**DEVIATION REVIEW
 AND DECISION FORM**

Subdivision or Project Name: Homestead at SR Filing No. 2

**DEVIATION REQUEST EXHIBIT HOMESTEAD AT SR FILING NO.2
 ECM 3.3.1.J.8 EXCEEDING MAXIMUM VELOCITY 18 FPS**

STORM 3 STA 1+00.00 TO STA 7+63.63

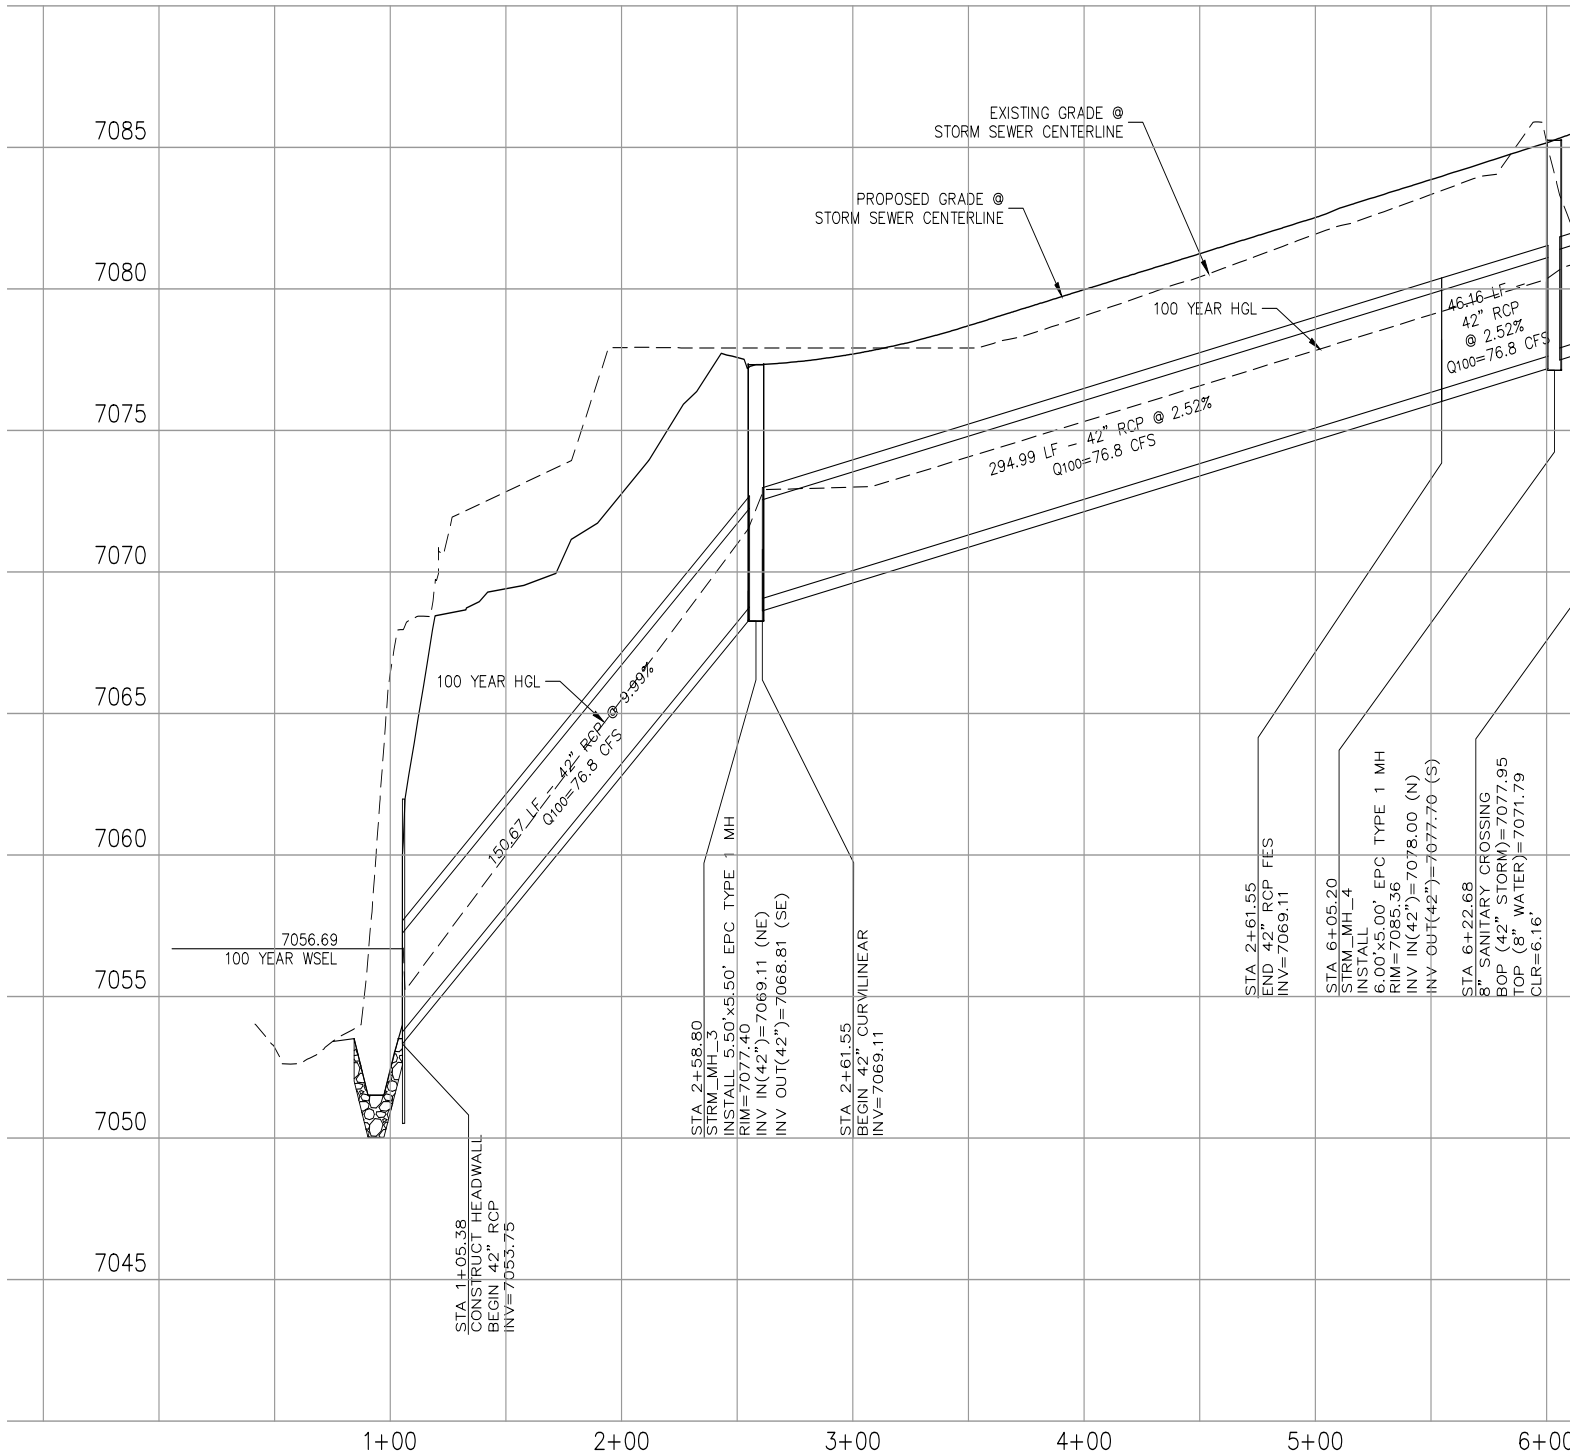
Proposed Nature and Extent of Deviation: The following section of storm sewer exceeds 18 fps. Storm 3 - btw Sta 1+05.38 - Sta 2+58.80.

Reason for the Requested Deviation: Due to hydraulic storm sewer design and outfall into Sand Creek, in avoidance of excessively deep storm sewer construction and maintenance.

Comparison of Proposed Deviation to ECM Standard: Only the section of pipe between Sta 1+05.58 and sta 2+58.80 promote velocities exceeding 18 fps. The entire pipe system does not promote excessive velocities. Pipe segments that have flows in excess of 18 fps will be made of 5,000 psi pipe as shown on plans.

NOTES:
 STA 1+05.58 TO STA 1+29.58
 (NEXT FULL JOINT) TIE PIPE
 SEGMENTS TOGETHER W/4- $\frac{3}{4}$ "
 CANOPY TYPE ROD LUG JOINT
 FASTENERS.

REINFORCED CONCRETE PIPE INSTALLED
 BETWEEN STA 1+05.58 AND STA 2+58.80
 SHALL BE FABRICATED USING A CONCRETE
 MIX DESIGN THAT RESULTS IN A MIN. 5000 PSI
 COMPRESSIVE STRENGTH.
